**REVIEW OF HYDRODYNAMIC LOADS ON EMERGENCY
CORE COOLING SUCTION STRAINERS**

Office of Nuclear Reactor Regulation

18 May 2001

Figure 2 Drag coefficient and the buoyancy-corrected Inertia coefficient for a perforated sphere, originally used by Wills.

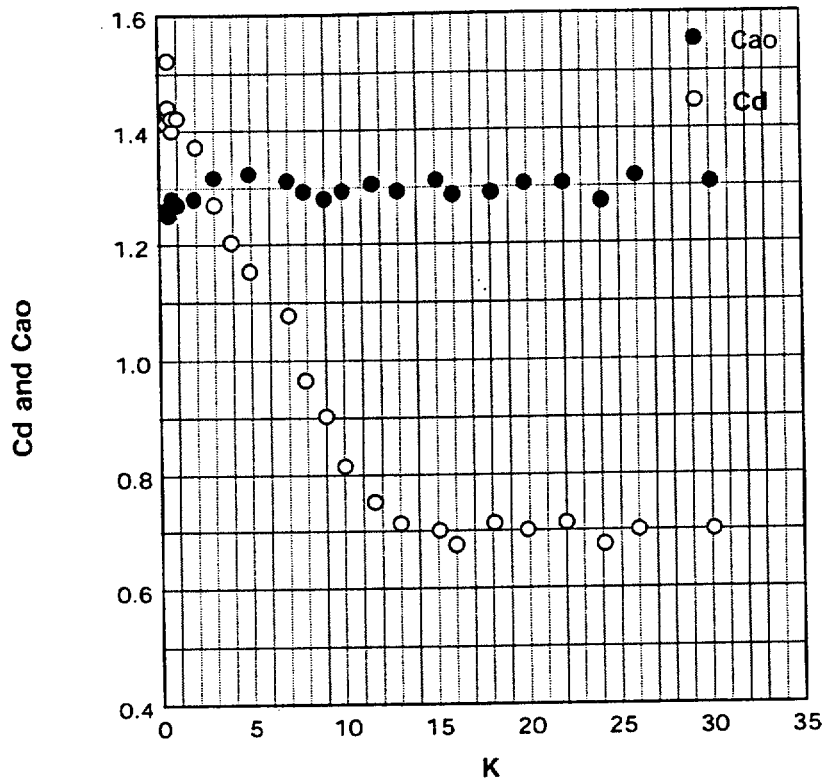
During the past year, the original spherical ball provided by Wills has been subjected to extremely careful experiments with better instrumentation, particularly at very low K_D values, using oscillations in air and in water at frequencies as large as 6 Hz. As noted above, the earlier experiments (1975) were conducted at very low frequencies and the measurement of forces was rather difficult and subject to large scatter at relatively small K_D values. The new data, together with those at higher K_D values, are shown in Fig. 2.

First, it must be emphasized that in this and in all other figures to follow, C_{a0} is the 'inertia coefficient', 'corrected for the buoyant force' (see Eqs. 9 and 11). Figure 2 does not resemble the old data reported in Wills, particularly at K_D values smaller than about 4. The coefficient C_{a0} does not fall below about 1.26 even for K_D values as small as 0.04. This is because of the profound effect of the unsteady shear on the added mass coefficient at high frequencies. Likewise, the drag coefficient continues to rise without any tendency to decrease.

Figure 4. Drag and buoyancy-corrected inertia coefficients for a porous cylinder with a porosity of 30%.

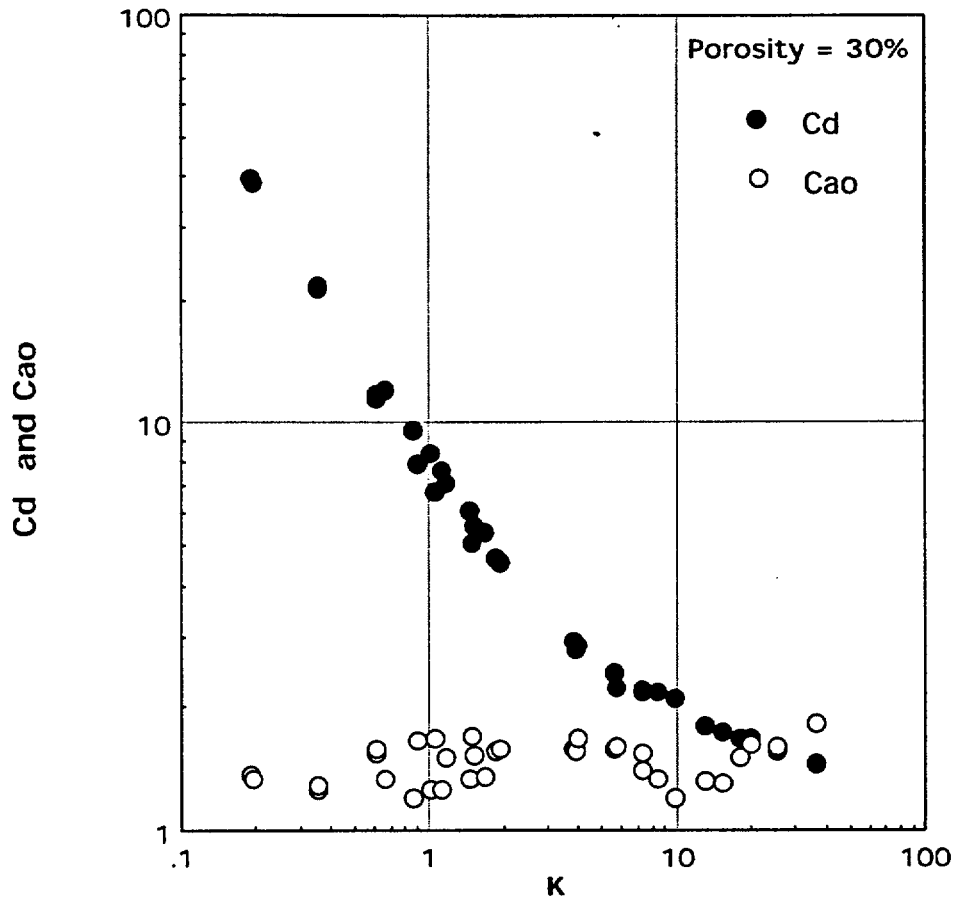
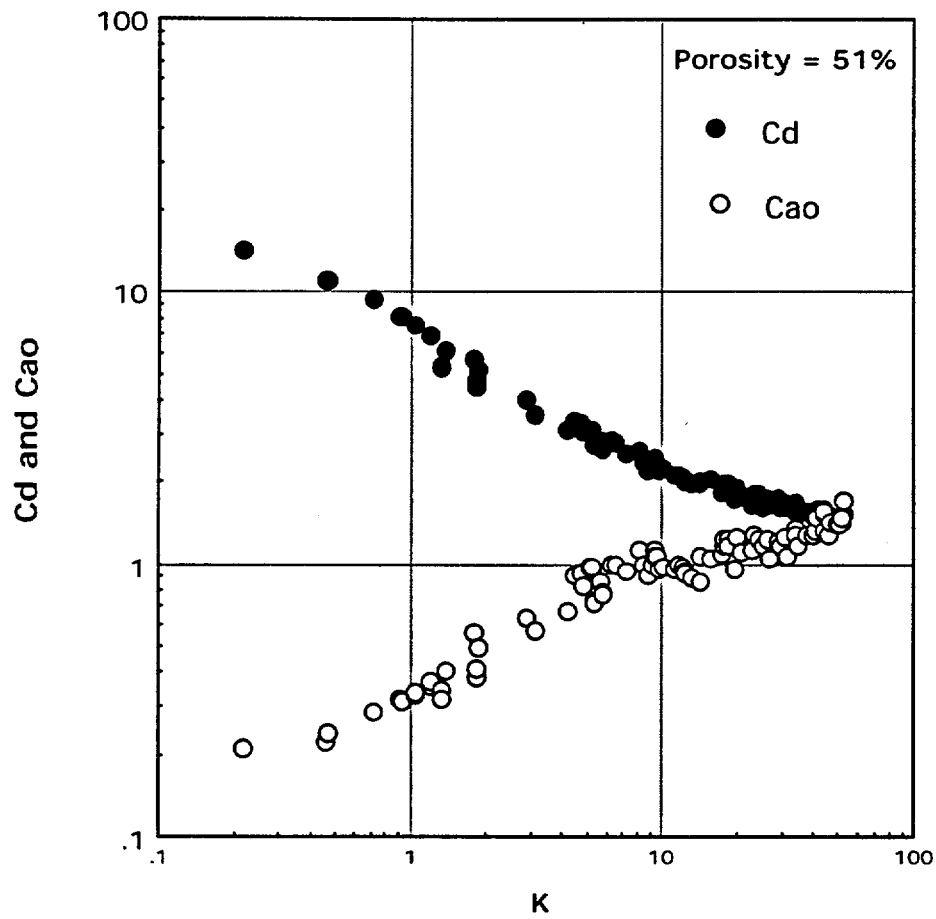
Representative data from Osgood's work are shown here in Figs. 4 and 5 for the porosities of 30% and 51% only. It is clear that the drag coefficients can reach very high values. It is also clear that C_{ao} strongly depends on the porosity. For a cylinder of 30% porosity, it is about 1.2 at $K = 0.18$. For a cylinder of 51% porosity, however, C_{ao} decreases to about 0.2 at $K = 0.2$. In order to fill the gap between the porosities of 30% and 51%, the on-going investigation was extended to several cylinders of 40% porosity. The results of these measurements are shown in Fig. 6. Clearly, C_{ao} has increased to about 0.3 at $K = 0.03$.

Figure 7. Drag and buoyancy-corrected inertia coefficients for porous cylinder of 30%, 40%, and 51%.

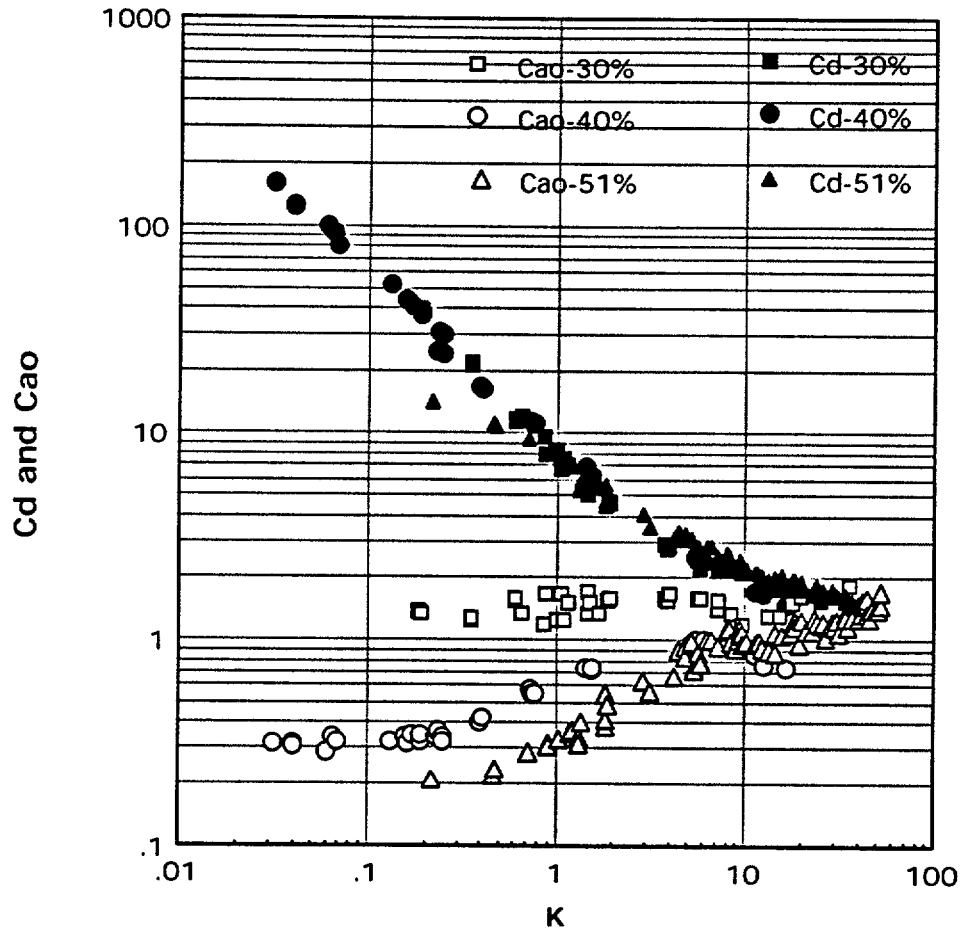
In order to simplify the comparison of the said coefficients for three porosities, the data shown in Figs. 4, 5, and 6 are re-plotted in Fig. 7. It is evident that the inertia coefficient for the cylinder with 40% porosity is somewhat larger than that

for the 51% porosity. This is not surprising. It is, in fact, a convincing demonstration of the facts surrounding the variation of the inertia coefficient and its dependence on porosity. We have every reason to believe that the inertia coefficient of a perforated cylinder with a porosity [REDACTED] [REDACTED] for all values of the frequency parameter [REDACTED]. The data shown in Fig. 7 present enormous mathematical and numerical challenges. It is our conjecture that GE strainers [REDACTED] [REDACTED] cannot have C_{ao} values smaller than about [REDACTED] at proper Keulegan-Carpenter numbers and frequency parameters. A "correct" model experiment of the strainer will go long ways to prove the validity of one and all assertions.
